THREE MILE ISLAND NUCLEAR STATION, UNIT 1

AMENDMENT TO FACILITY OPERATING LICENSE

Amendment No. 5
License No. DPR-50

ATTACHMENT TO LICENSE AMENDMENT NO. 5
CHANGE NO. 5 TO THE TECHNICAL SPECIFICATION
FACILITY OPERATING LICENSE NO. DPR-50
DOCKET NO. 50-289

FIGURE 3.1-1

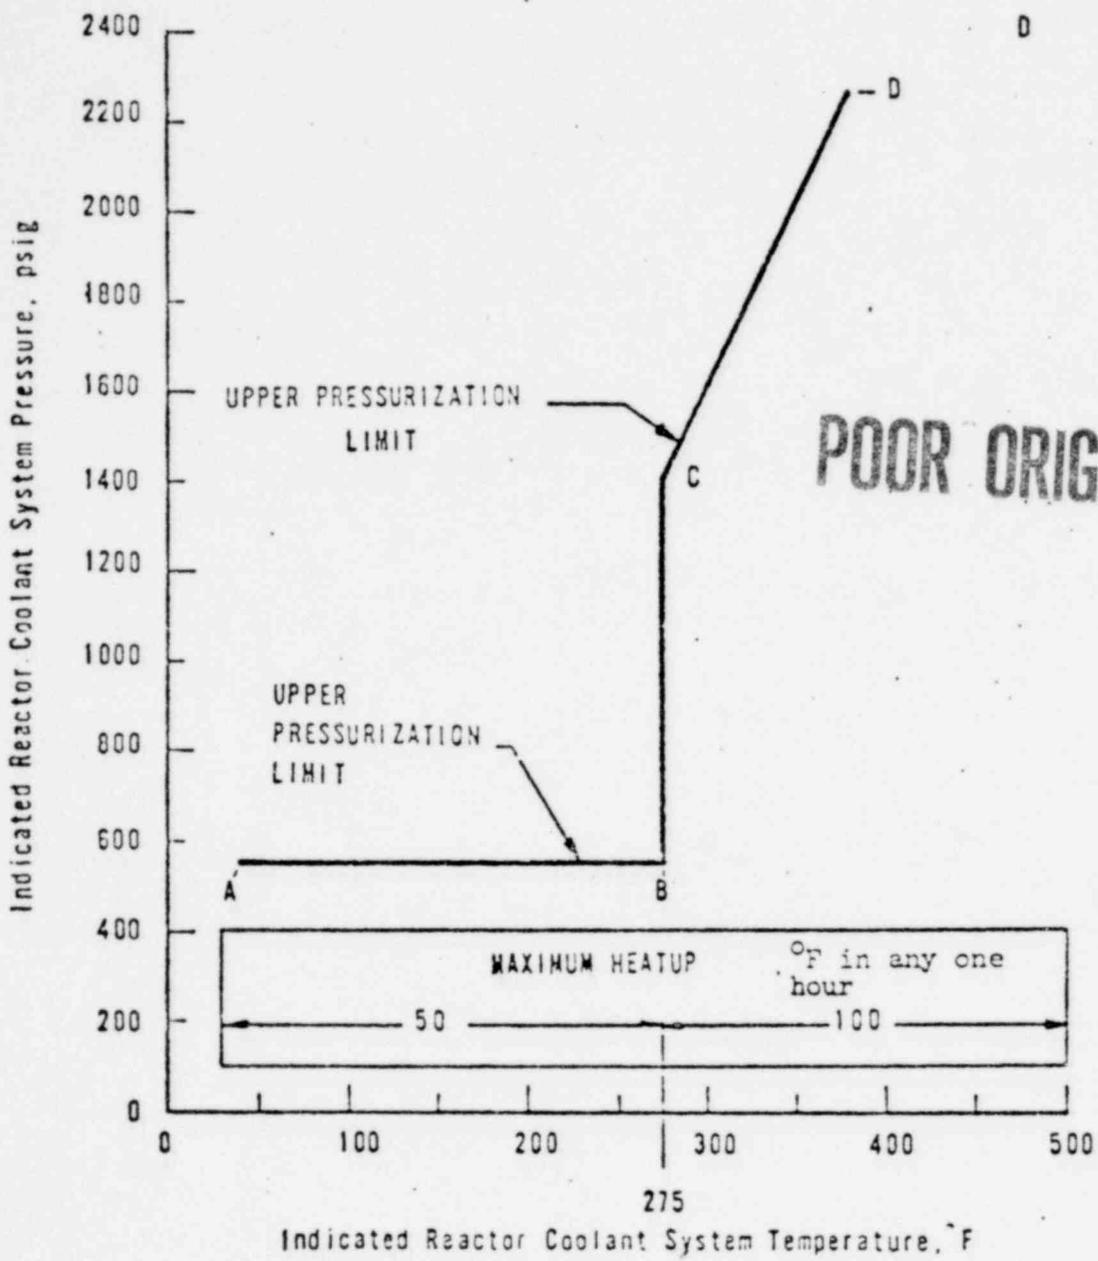
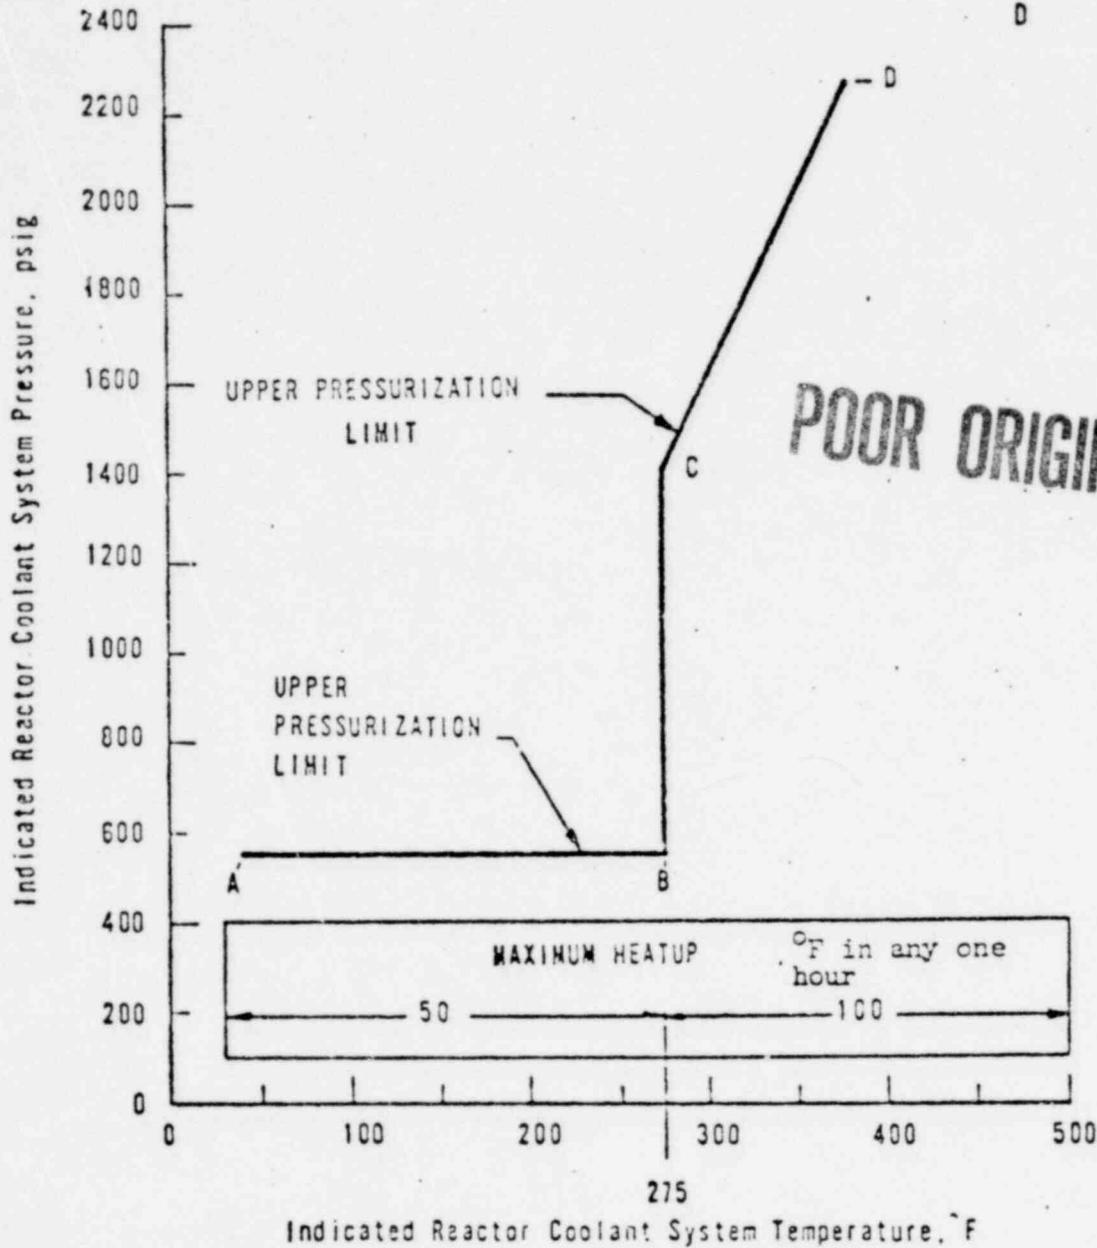
Replace pages 3-3, 3-4, and 3-5 with the attached revised pages.
Replace page 3-6 with the attached page (no change was made therein but
is being replaced for numbering sequence only). Also, replace Figures
3.1-1 and 3.1-2 with the attached revised figures.

Allowable combinations of pressure and temperature shall be to the right of and below the limit line in Figure 3.1-1. Heatup rates shall not exceed those shown on Figure 3.1-1.

For adequate conservatism, in lieu of portions of the Fracture Toughness Testing Requirements of the proposed Appendix G to 10 CFR 50, a maximum pressure of 550 psig and a maximum heatup rate of 50°F in any one hour has been imposed below 275 F as shown on Figure 3.1-1. | 5

POINT	TEMP.	PRESS.
A	40	550
B	275	550
C	275	1400
D	380	2275
